| REVISION NUMBER | DATE | MADE BY | APP'D BY | REVISION |
|-----------------|------------|---------|----------|-----------------|
| 1 | 07/02/2021 | RKC | DF | BID ADDENDUM #3 |

INFRASTRUCTURE REHABILITATION - PHASE 2
PLAYLAND PARK, RYE, NEW YORK
GENERAL
DUCT BANK PLAN 2

20-530

GE-E-05

3 ENLARGED PLAN
GE-E-04 SCALE: 1" = 20'

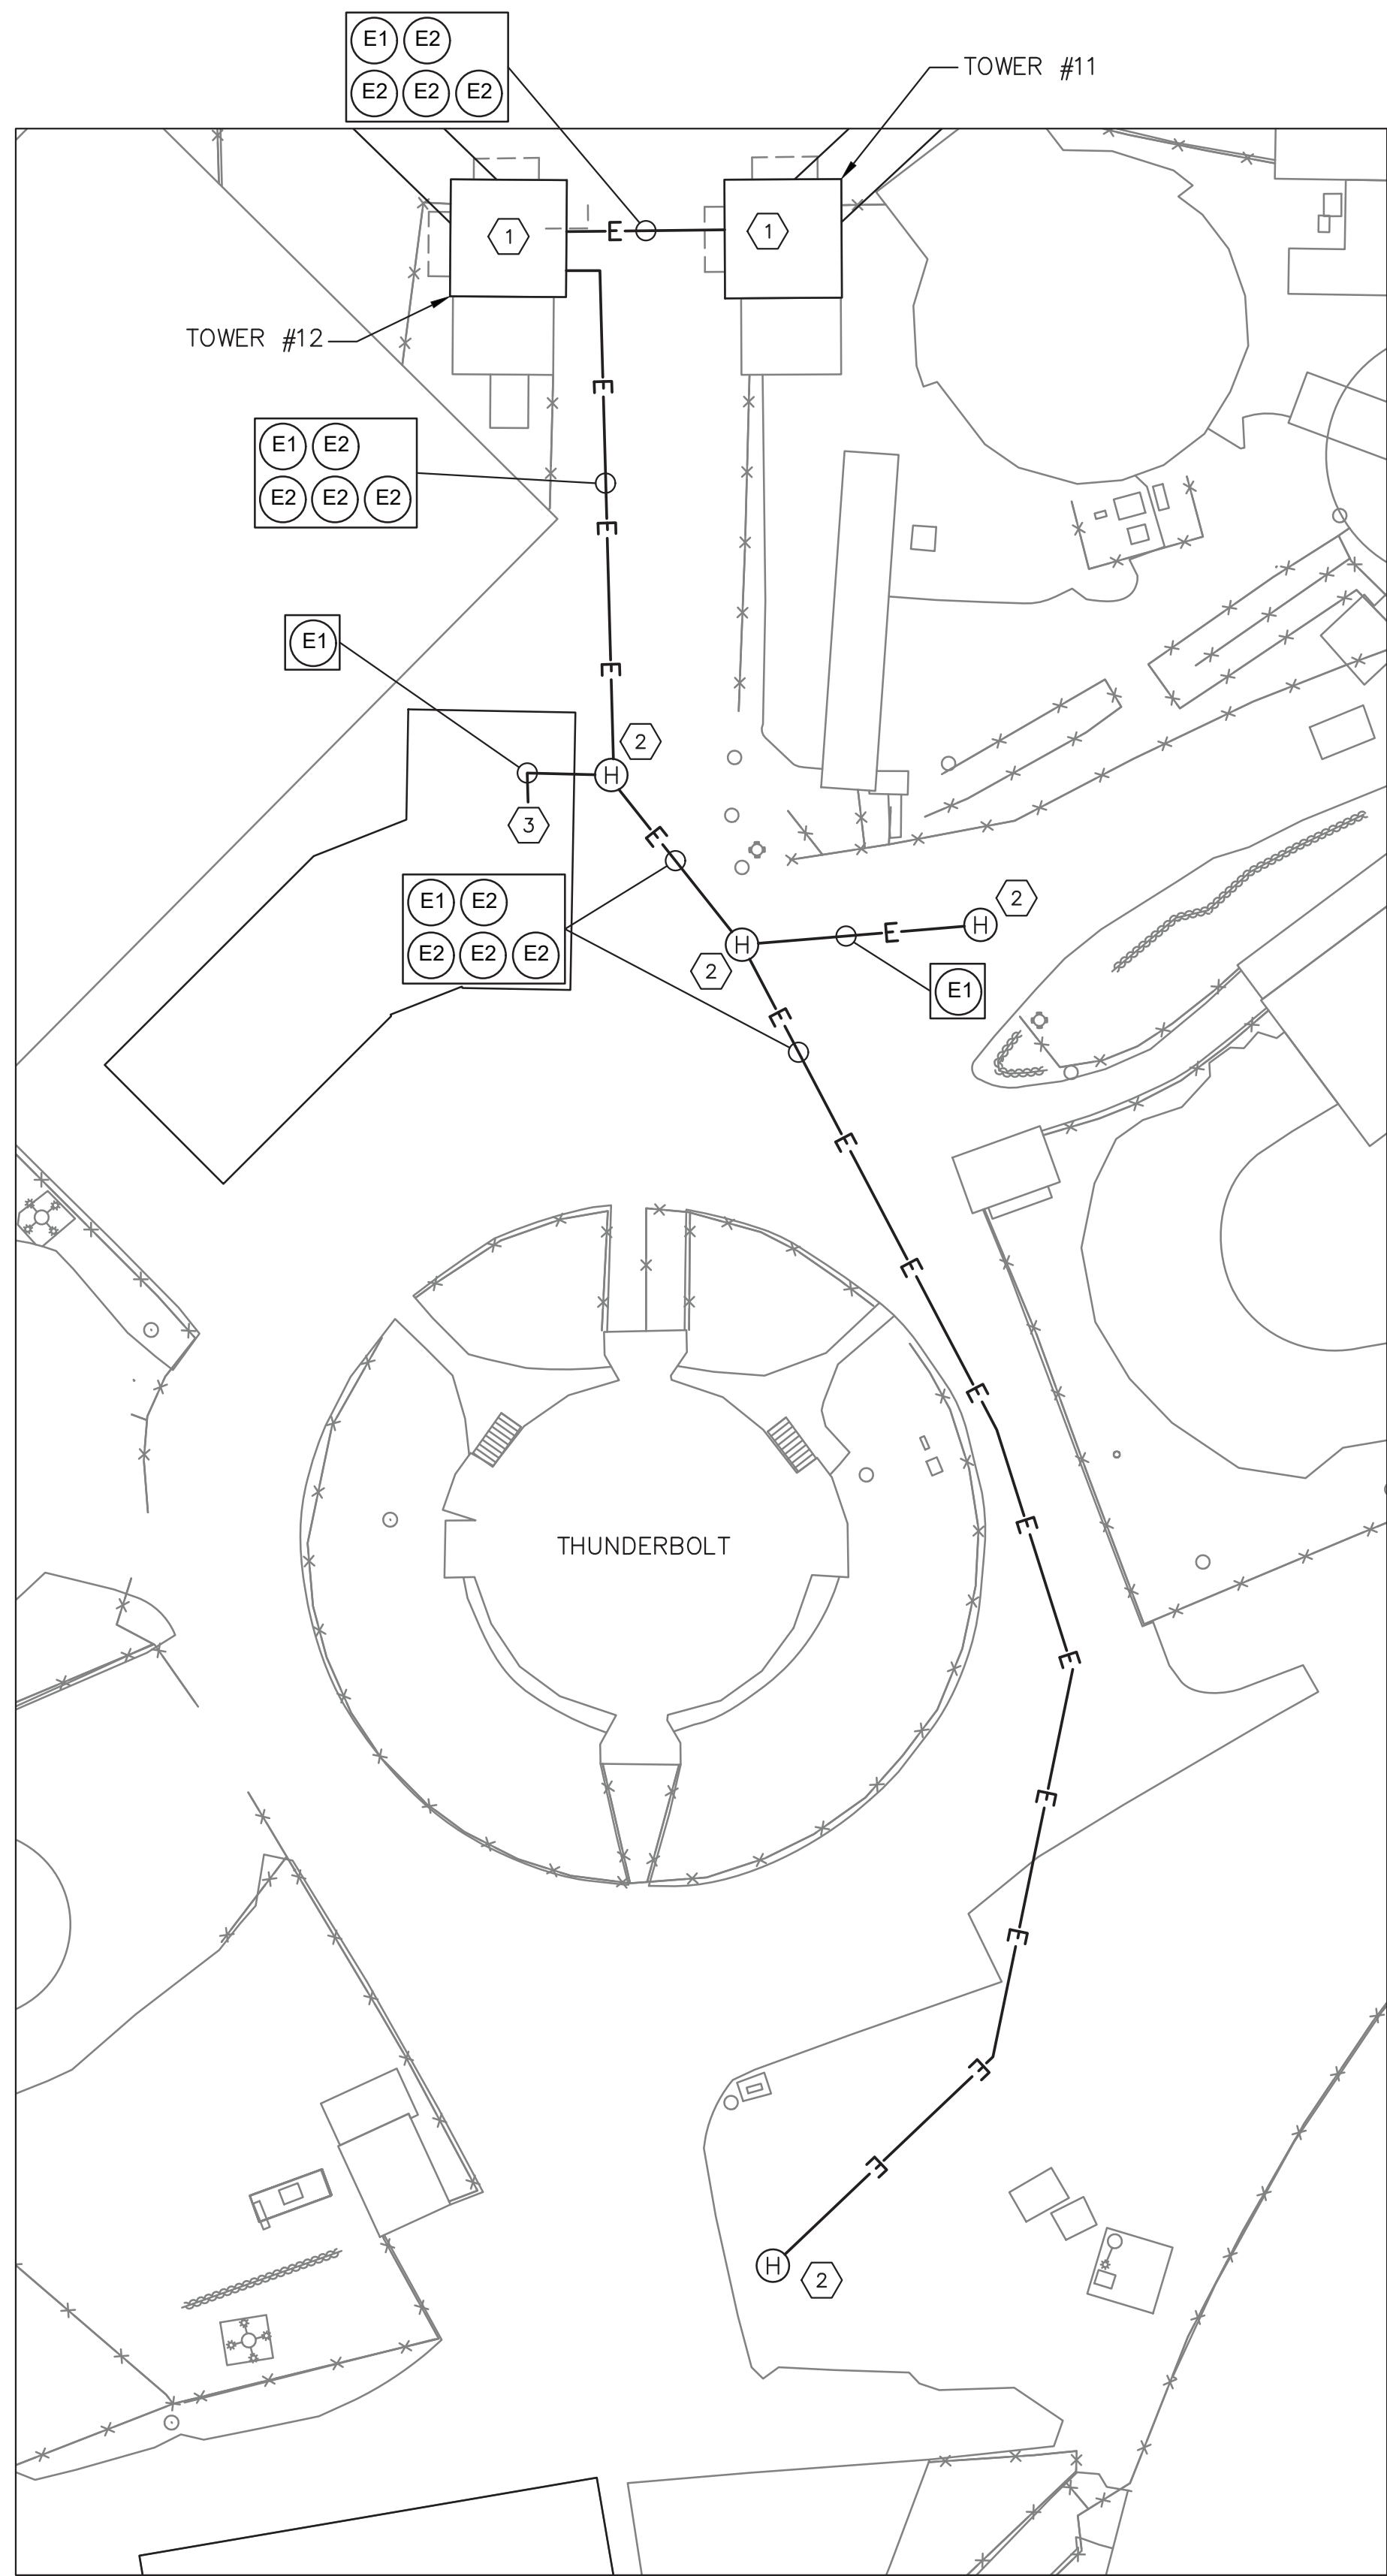
- 1 TOWER WILL HAVE NEW MANHOLE INSTALLED (SEE MAW-1 ADDENDUM STRUCTURAL DRAWINGS FOR ADDITIONAL INFORMATION). INCOMING UNDERGROUND CONDUIT WILL BE ROUTED TO NEW MANHOLE. CONTRACTOR IS ADVISED, UNDER THE MEGA 1 PROJECT, UNDERGROUND CONDUIT WILL BE INSTALLED AND CAPPED 8" PAST THE TOWER FOOTPRINT. MEGA 2 CONTRACTOR WILL INTERCEPT (AT THIS POINT) AND INSTALL NEW CONDUIT AS SHOWN.
- 2 PROVIDE 18" X 18" X 24" POLYMER CONCRETE MANHOLE AT THIS LOCATION.
- 3 INCOMING UNDERGROUND CONDUIT SHALL BE ROUTED TO ATTIC SPACE OF STRUCTURE. CONCEAL EXPOSED CONDUIT AS MUCH AS PRACTICAL. STUB AND CAP CONDUIT FOR FUTURE USE.
